HIGHLAND CITY DEVELOPMENT ADMINISTRATION BOARD AGENDA

DEVELOPMENT ADMINISTRATION BOARD AGENDA REPORT ITEM #1

DATE: October 10, 2024
TO: Development Administration Board
FROM: Rob Patterson, City Attorney / Planning & Zoning Administrator
SUBJECT: **Final Plat Approval:** Ridgeview Plat L
TYPE: **LAND USE (ADMINISTRATIVE)**

ATTACHMENT 6

Scale: 1"=20'
Date: 09/09/24
Sheet: PP04

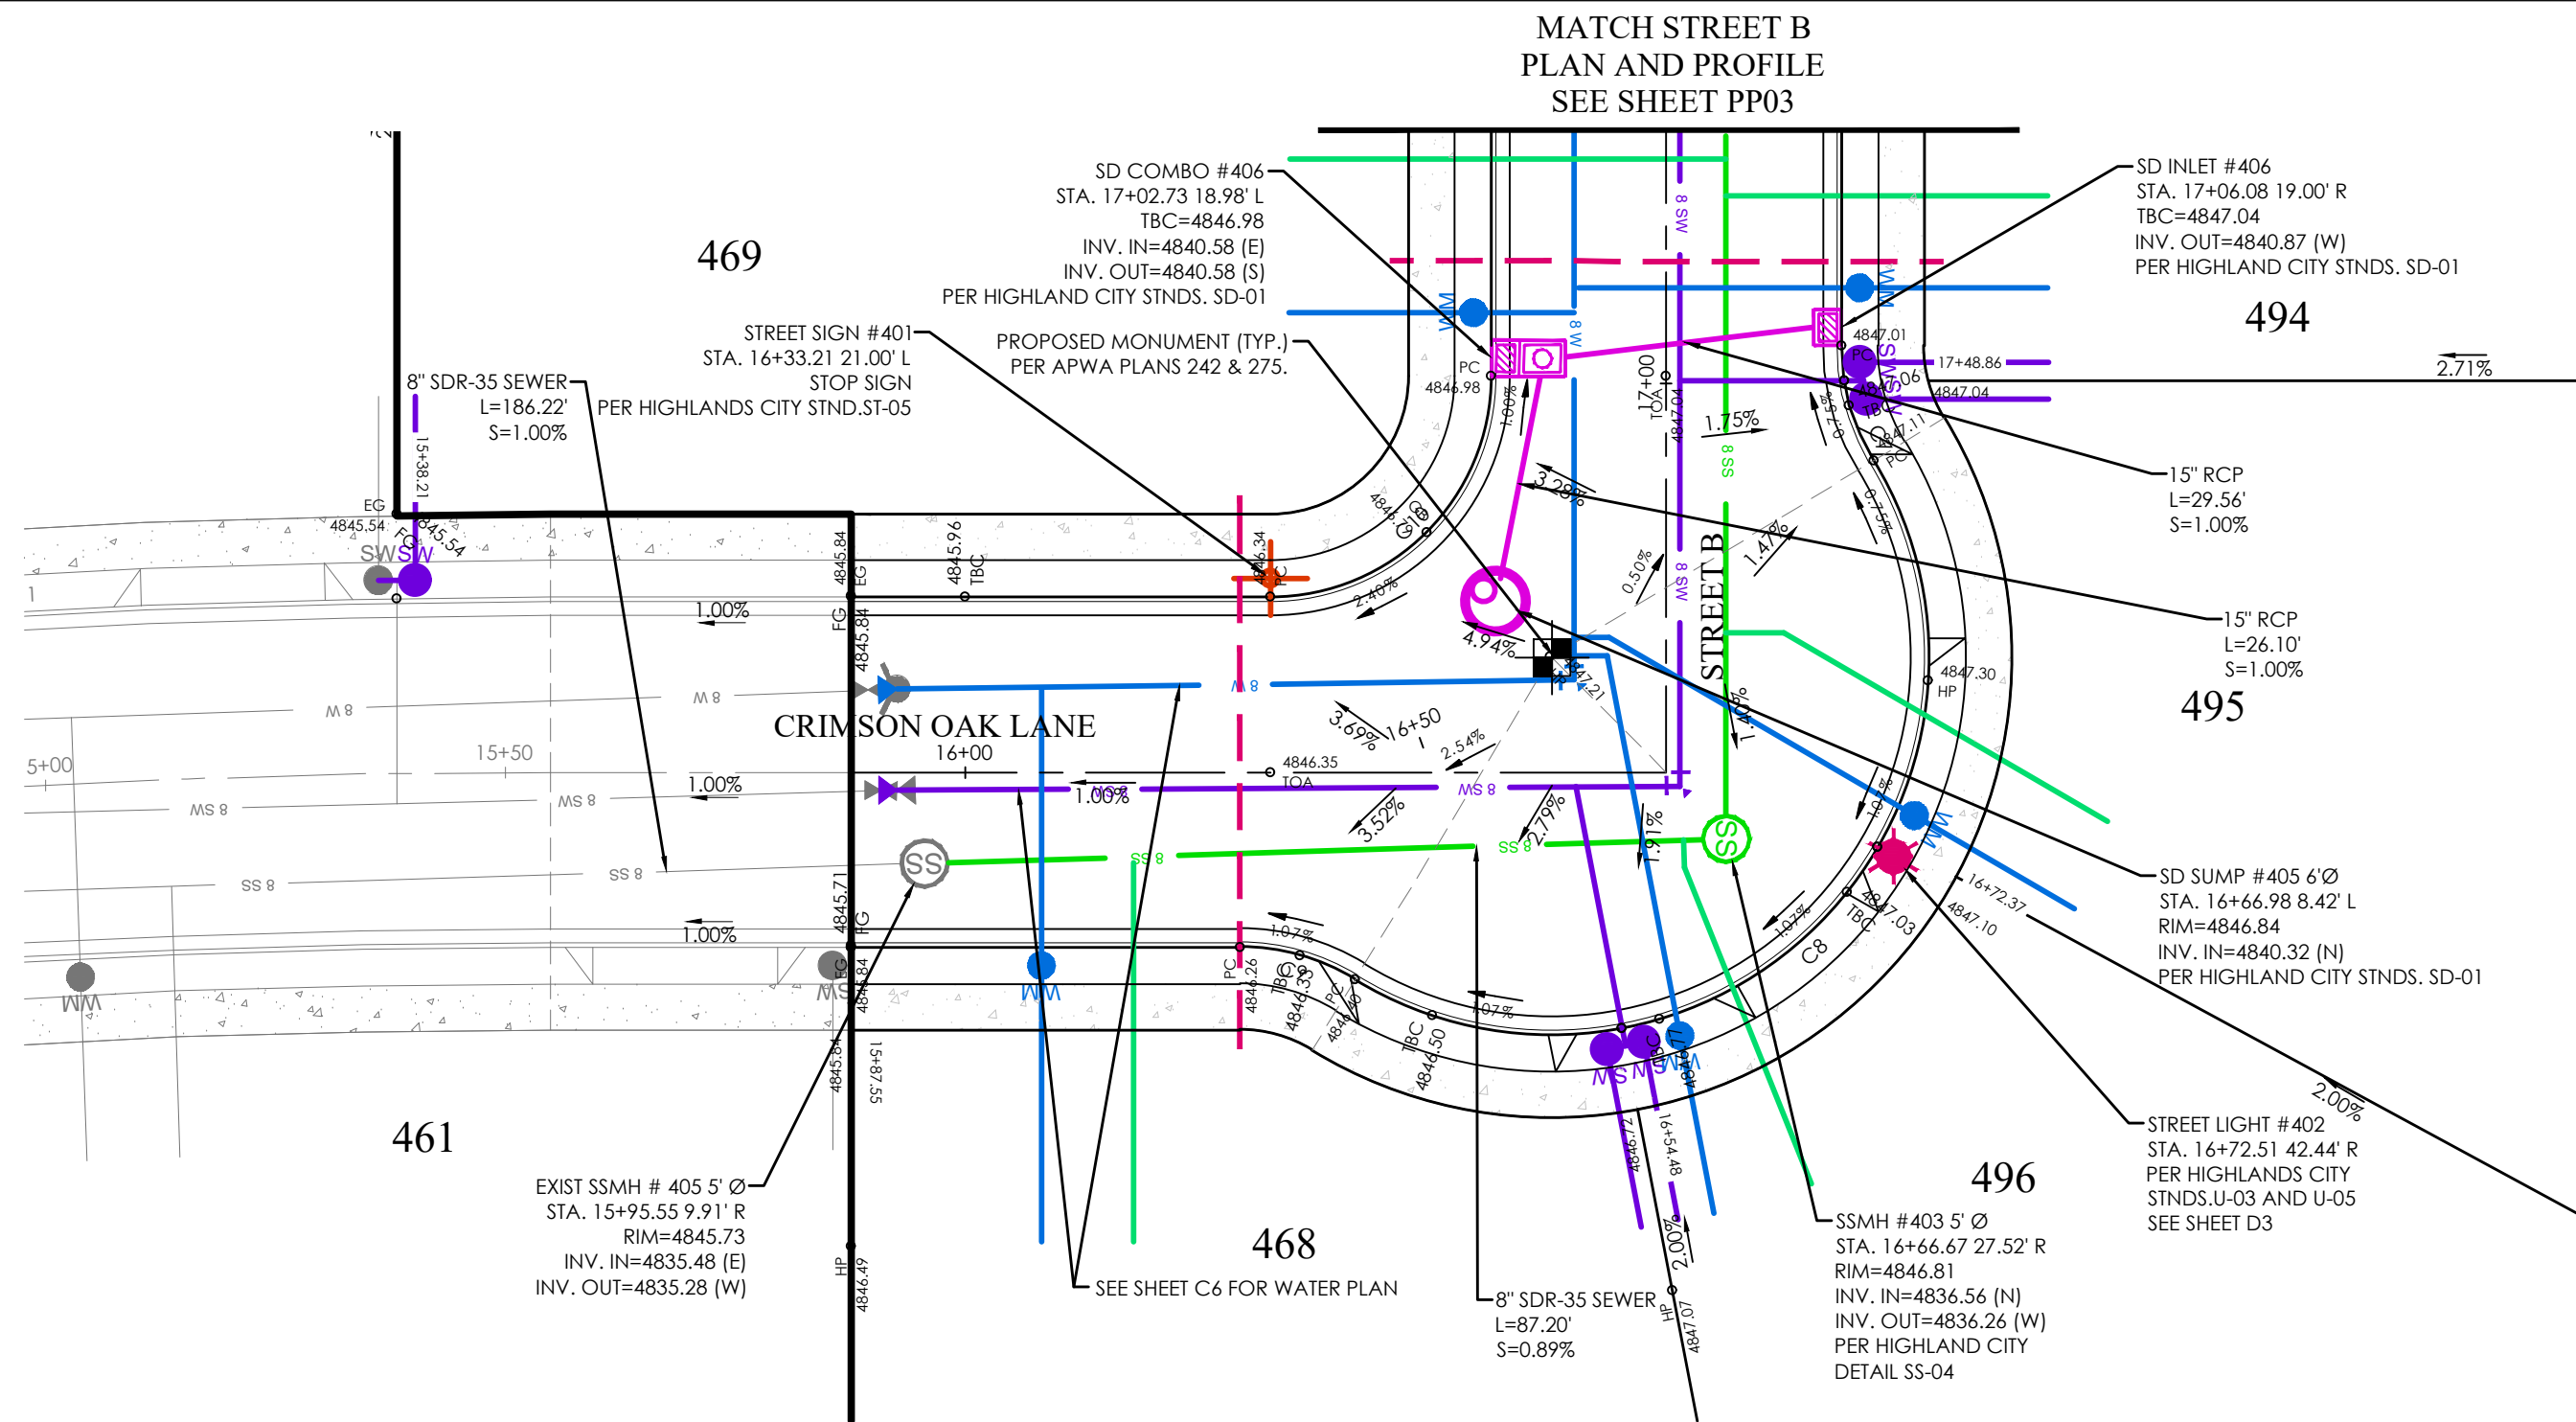
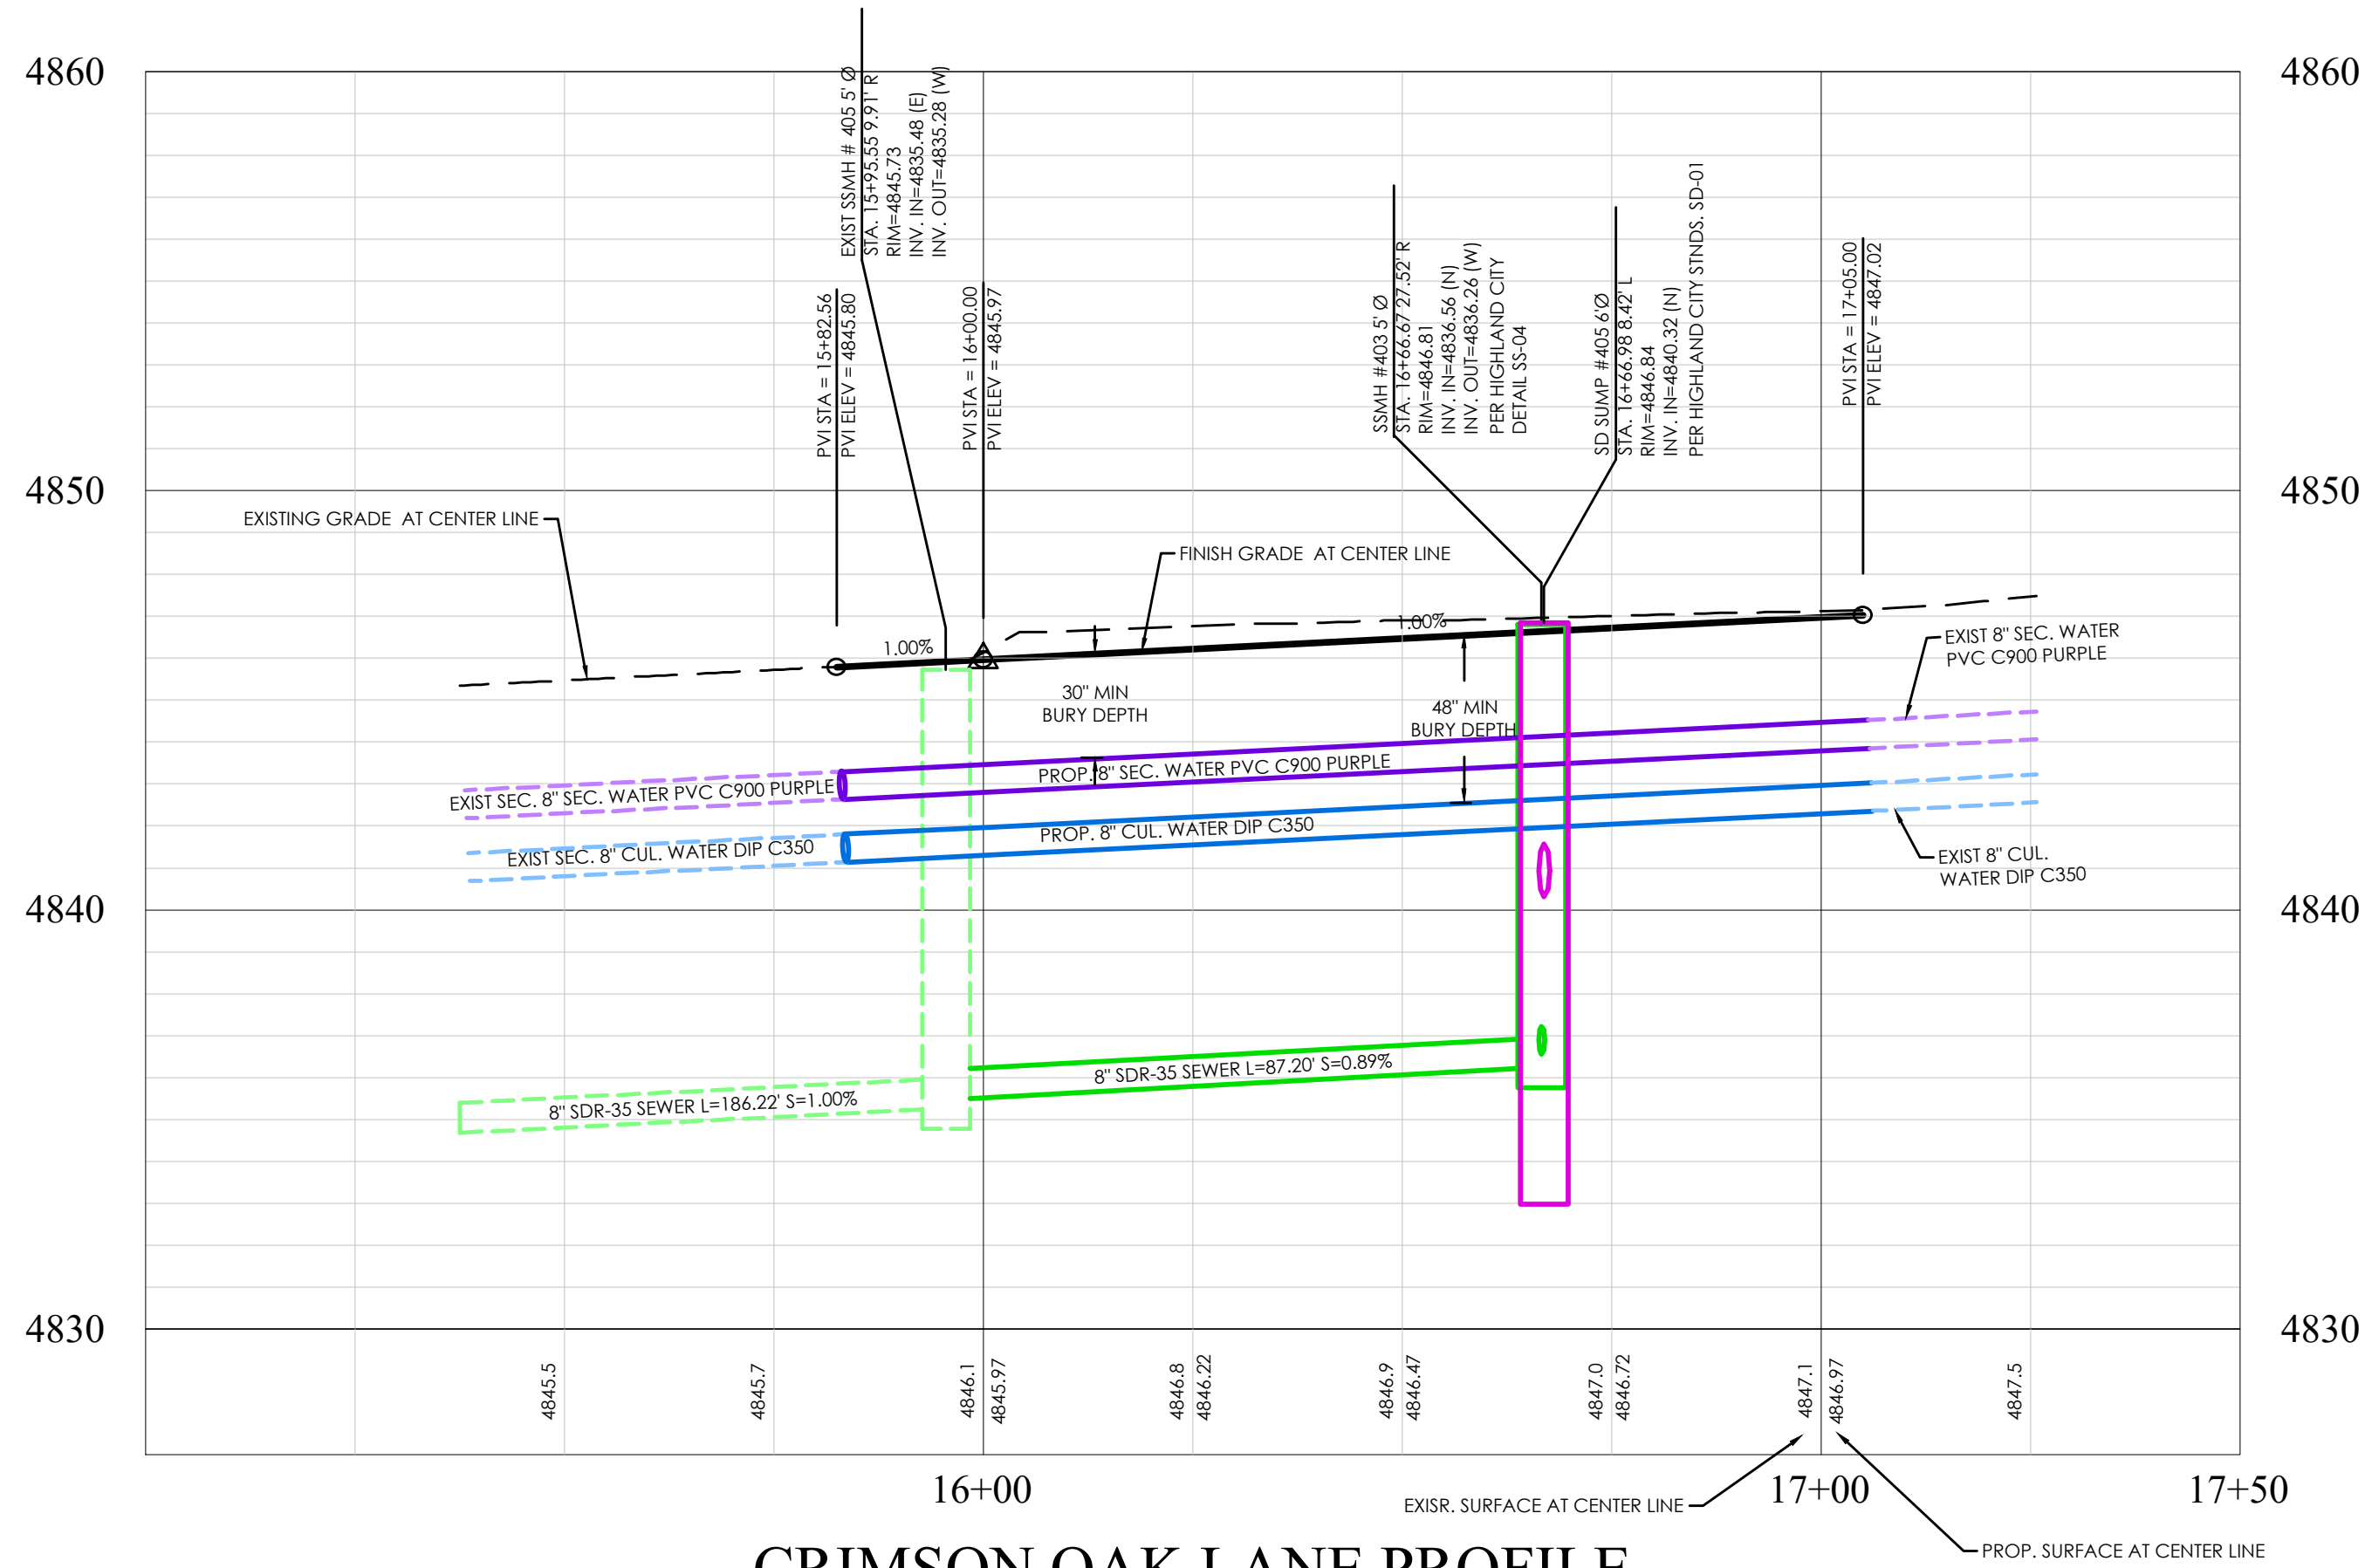
4. Green Ash Lane/Street B, Sheets PP01, PP02, PP03: Remove "Street B" from match lines and from plan views.
5. Crimson Oak Lane, Street Monument, Sheet PP04: Please provide reasoning for the location of the street monument. It does not mark the intersection of the two streets.
